**PLANNED UNIT DEVELOPMENT  
& SUBDIVISION STAFF REPORT****Date: May 7, 2009****DEVELOPMENT NAME**

Josephine Allen Subdivision

Planned Unit Development Approval to allow multiple buildings on a single building site in a Multi-Family Residential District, and Subdivision approval to create 3 lots.

# SITE PLAN

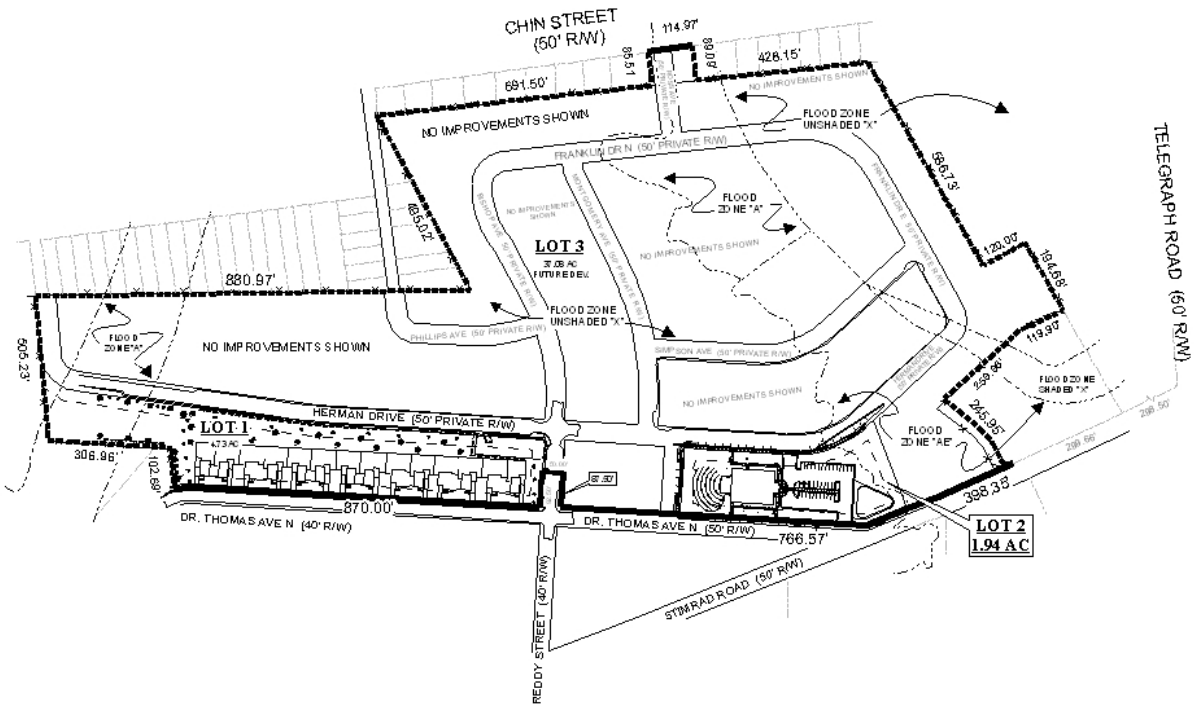
As Lot 1 is zoned R-3, full compliance with the tree and landscape requirements of the Zoning Ordinance will be required, however, the site plan lacks sufficient information for staff to determine if the requirements are fulfilled. Existing trees are not depicted on the site plan, thus Urban Forestry has requested a holdover of the application.

New sidewalks are depicted on the PUD site plan where new development is proposed. As the new residences will include accessible units, the applicant should ensure that continuous sidewalks are provided along all public and private street frontages where new development is proposed, and that the existing recreation center and proposed cultural arts center are accessible via sidewalk by the mobility challenged.

Planned Unit Developments require 700 square feet of “common open space” per dwelling unit (per section 64-5.C.2.c. of the Zoning Ordinance), however, the applicant has not indicated the amount of landscape or common area being provided on Lot 1, which contains the new dwelling units. The PUD site plan should be revised to show required common open space information, as well as the required tree and landscape information.

No dumpster is depicted on the site plan. If the residences or the cultural center site include dumpsters, they must be depicted on the site plan, and must be screened by a 6-foot high wooden privacy fence. If no dumpster will be used, a note should be placed on the site plan explaining how garbage pick-up will be undertaken.

- 4) Revision of the site plan to show full compliance with the tree and landscaping requirements of the Zoning Ordinance for proposed Lots 1 and 2, including calculations for landscape areas and required PUD common open space for development on Lot 1;

- 5) Revision of the site plan to show sidewalks along all public and private street frontages for those lots accommodating new development;
- 6) Revision of the site plan, if necessary, to provide adequate paved off-street parking area to ensure that driveway length leading to garage/carport can accommodate one full-size pick-up or SUV, with no overhang into the right-of-way or required sidewalk;

- 7) Revision of the site plan to depict a screen dumpster, if one will be used, or placement of a note on the site plan explaining how garbage removal is undertaken; and

- 8) Placement of a note on the site plan stating that any tree planted within 15 feet of an overhead powerline shall be either live oak (overstory) or crepe myrtle (understory), and depiction of any overhead powerlines that will remain after redevelopment.
